2301 7th Avenue  
DRB Response - REC Meeting #2  
Date: February 11, 2020  
SDCI Project Number: 3034280-LU

This package is in response to DRB comments from the September 24th, 2019 REC meeting with the goal of addressing all the comments and concerns from that meeting. The specific DRB comments and applicant responses are summarized on pages 4 and 5. Subsequently, each specific DRB comment has a response through graphics and text.

## DRB Guidance - SDCI notes of 09/24/2019 Rec. Meeting

## Summary of Applicant Response to DRB Guidelines

Site Plan

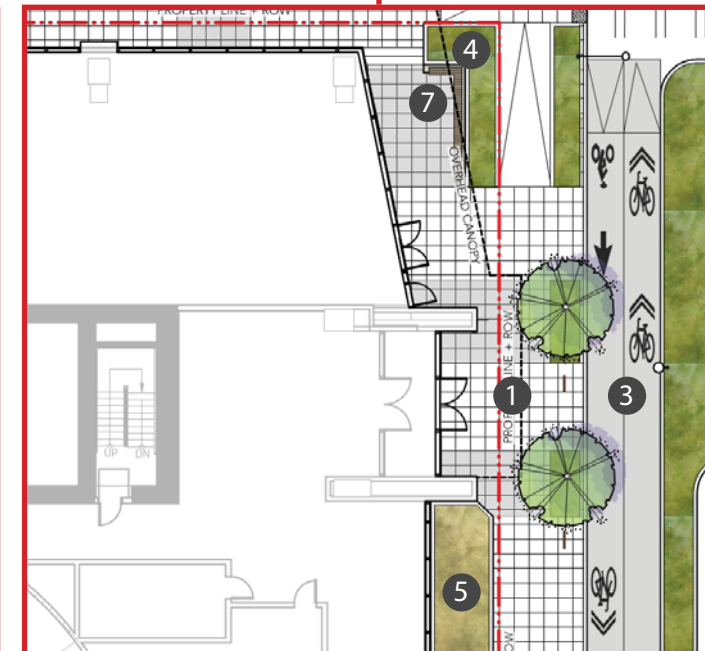
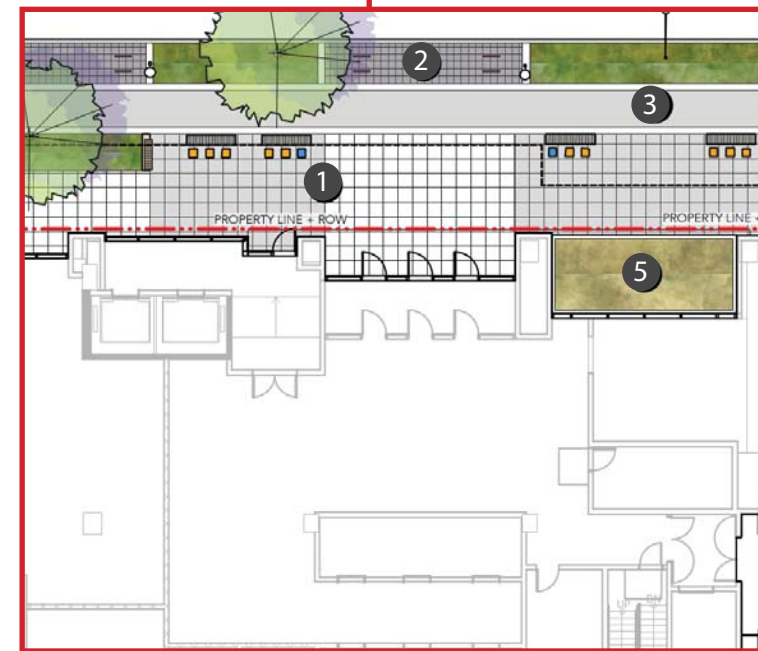
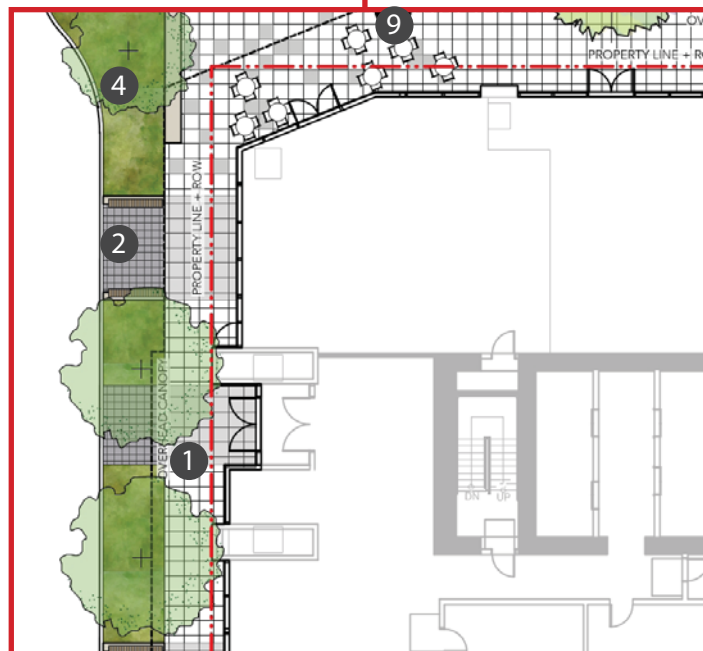
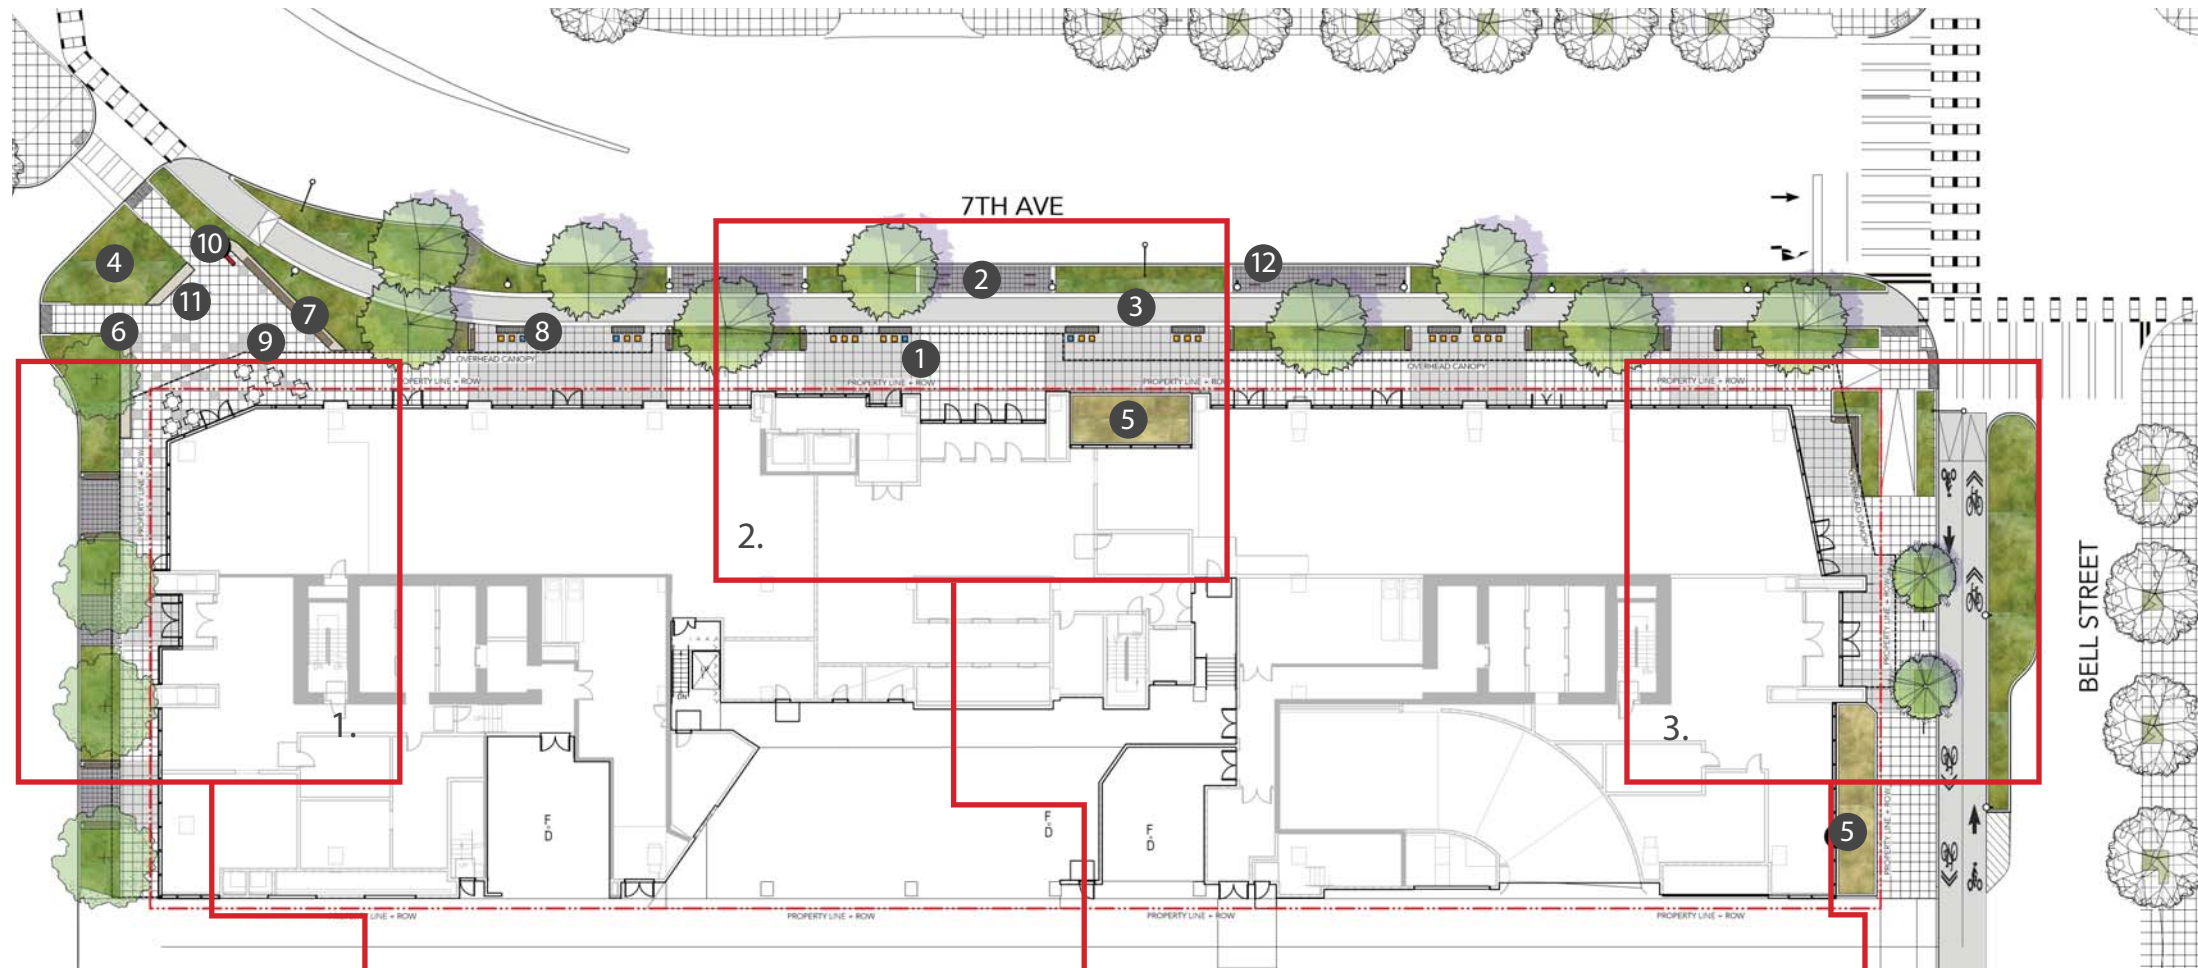
b. The Board directed the applicant to demonstrate the **alignments of paving patterns** with ground floor programming and entries. (C-4)

• Paving patterns and planter locations have been aligned with ground floor programming and entries, while taking into consideration street tree, lighting and furnishing locations, as well as Architectural building columns/forms.

**DRB Guidance - 3. Podium Massing and Expression  
7th Avenue Design Comparison**

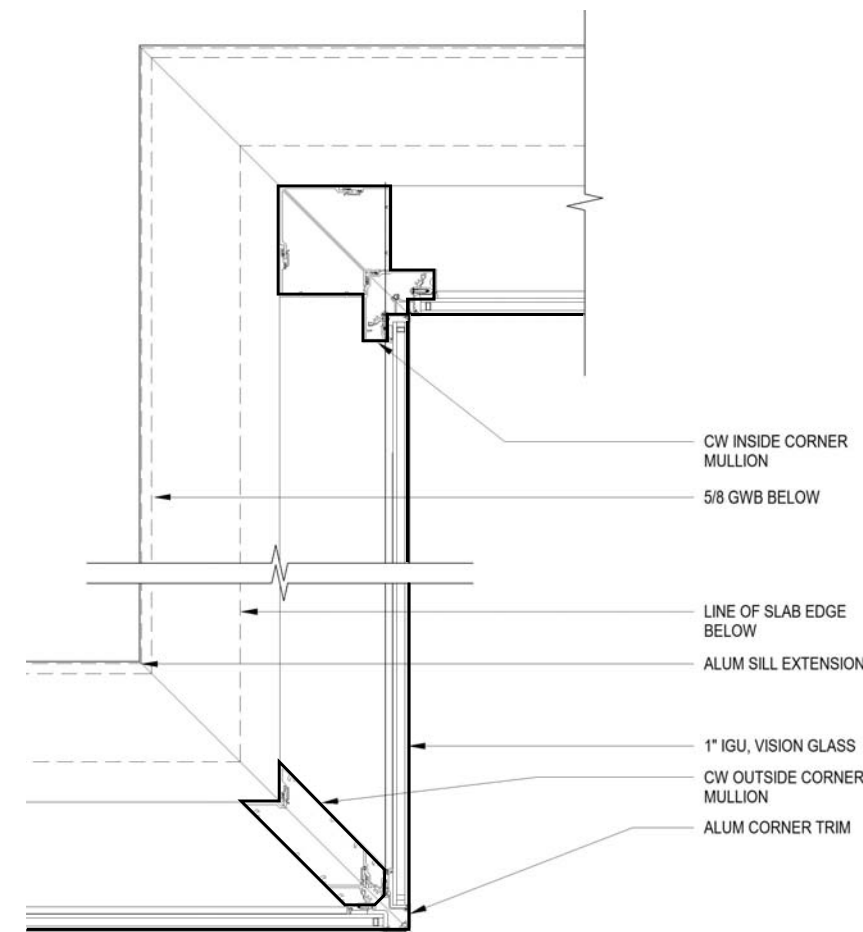
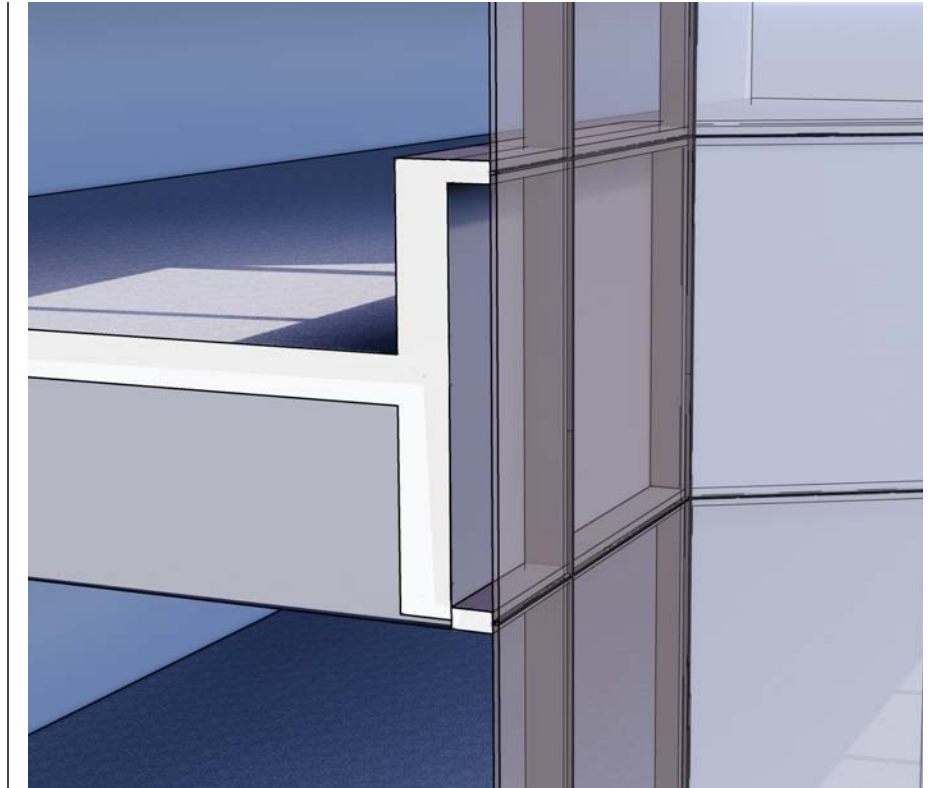
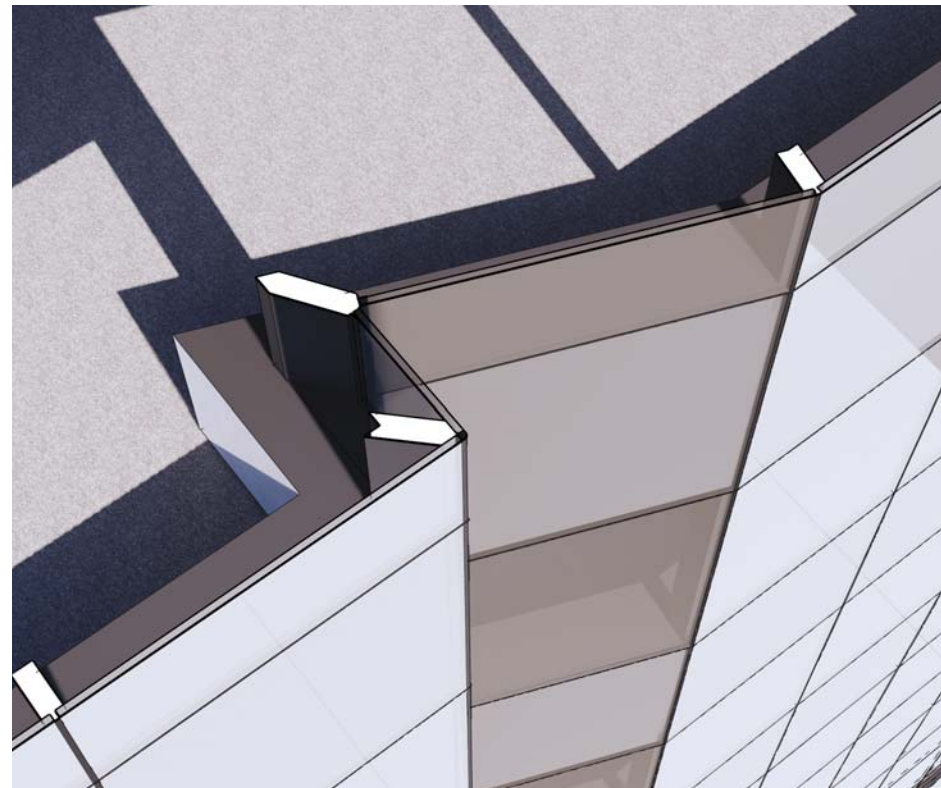
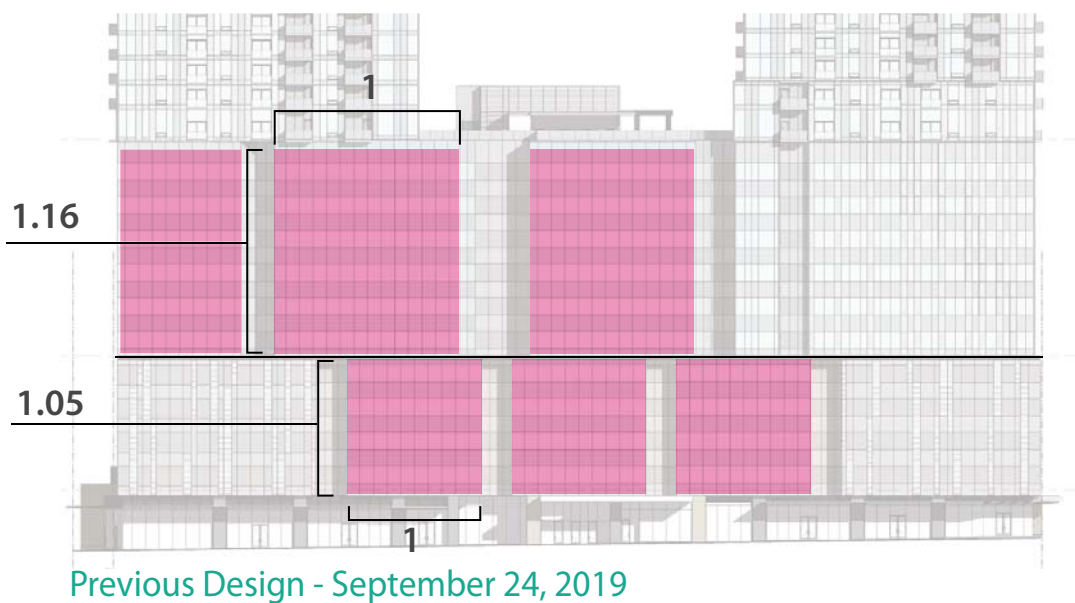
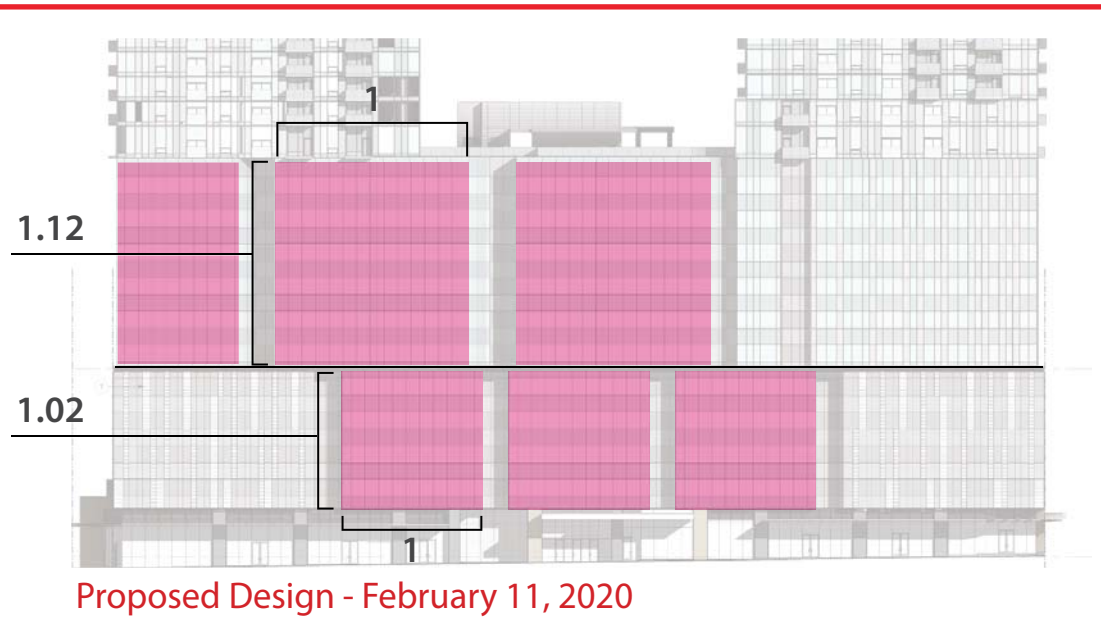
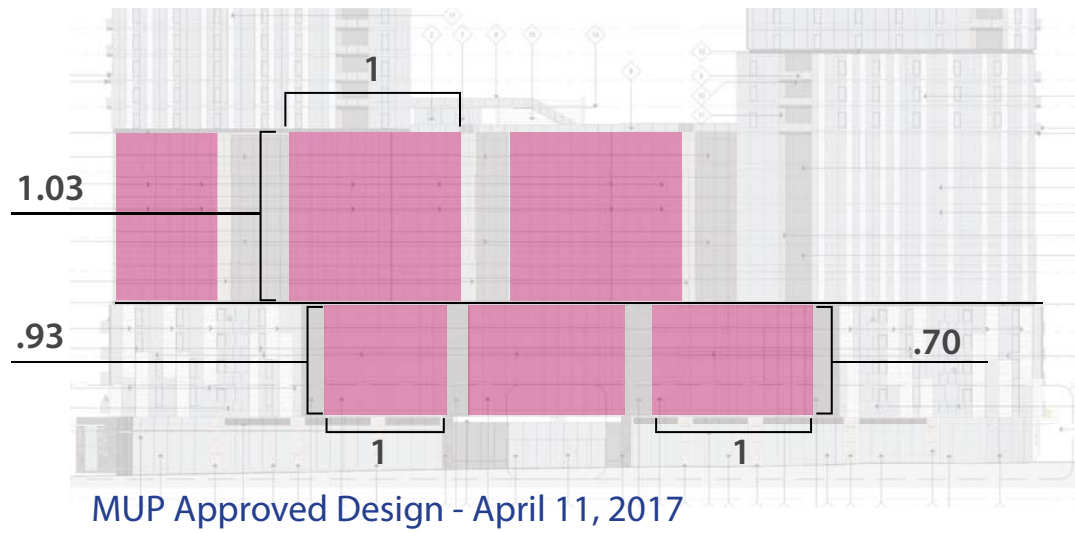
**a.** Loss of the **differently expressed programmatic elements** not successful in breaking down the scale of the podium. Need better **relationship between podium and tower** in terms of proportion and coherence, and overall composition. (B-2, B-4)

**b.** Successful aspects of the previously approved design was the **relationship between the 'block' towers and the podium**, and the **scale-mitigating** effect of the towers 'stepping' into the podium. Further development and articulation of the composition would be needed. (B-4, C-2)

**a.b.** In order to 1.) breakdown the scale of the podium into more **"differently expressed elements"** and 2.) build a better relationship between said podium and "block" towers comparable with the MUP Approved Design, the applicant did the following:

- ① • Better proportioned and recognizable "cubes/squares" in the upper and lower podium.
- ② • Increase terracotta detail at lower podium book ends and wrap around to alley-side.
- ③ • Add Darker glass in the recessed portions of podium. Utilize shadow box detail for spandrels to add additional visual depth.
- ⑤ • Add vertical scoring to upper podium to further separate the upper from the lower podium- similar to the Approved MUP.
